February 14, 2023

Re: Draft Environmental Impact Statement for Coastal Virginia Offshore Wind Project

Please accept these comments from the Mid-Atlantic Fishery Management Council (Mid-Atlantic Council) and the New England Fishery Management Council (New England Council) regarding the draft environmental impact statement (DEIS) for the Coastal Virginia Offshore Wind (CVOW) Project. The DEIS analyzes the potential environmental impacts of five alternatives, including a no action alternative, the project as described in the Constructions and Operations Plan (COP) submitted by Dominion Energy (i.e., the proposed action), and three alternatives to the proposed action. After considering comments received through this comment period, BOEM will publish a final environmental impact statement (FEIS). The FEIS will inform BOEM's decision to approve, approve with modifications, or disapprove the COP.

Figure 1: Left panel: Shoal³ locations as indicated in Pickens and Taylor (2020; see footnote 2) as shown on the MARCO data portal. Right panel: Illustration of Alternative C in the CVOW DEIS, with areas identified as sand ridge habitat indicated in red polygons.

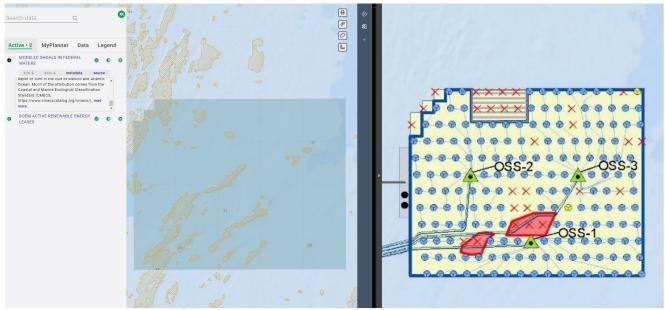
Alternative C includes the same layout as Alternative B, avoiding the fish haven area and the proposed vessel traffic fairway, and also removes four additional turbines to avoid sand ridge habitat. This would result in a maximum total number of 172 turbines and a 2,528 MW facility. Only 14 MW turbines are under consideration for this alternative. The description of this alternative is very brief and does not provide enough details on the importance of sand ridge habitat. Additional information on the data used to define these areas should be provided to help readers understand why these four specific locations were chosen for removal.

As shown in the figure below, we compared the distribution of sand ridge features identified via BOEM and NOAA's shoalMATE analysis (Pickens and Taylor 2020)² to the priority sand ridge areas

and the overall lease area. Based on this data set, there are many sand ridges outside of the exclusion areas identified in Alternative C, including within the export cable corridors. Even under Alternative C, these additional sand ridges will be affected by placement of turbine foundations, site preparation, and trenching for interarray and export cables. Our understanding is that when installing cables in areas with larger sand bedforms (waves or shoals), the bedforms are first removed, and then trenching occurs below this baseline depth. These activities will have substantial impacts on sand ridges occurring throughout the project area.

We recommend approval of a combination of Alternatives C and D to reduce the potential for negative impacts to the area referred to as the fish haven, the proposed vessel traffic fairway, sand ridges, and sensitive onshore habitats. We also recommend that BOEM remove additional locations that overlap with sand ridges, for example as shown in the figure on the previous page. We recommend working with NOAA Fisheries habitat staff to optimize the final turbine and offshore substation locations to minimize impacts to sand ridges.
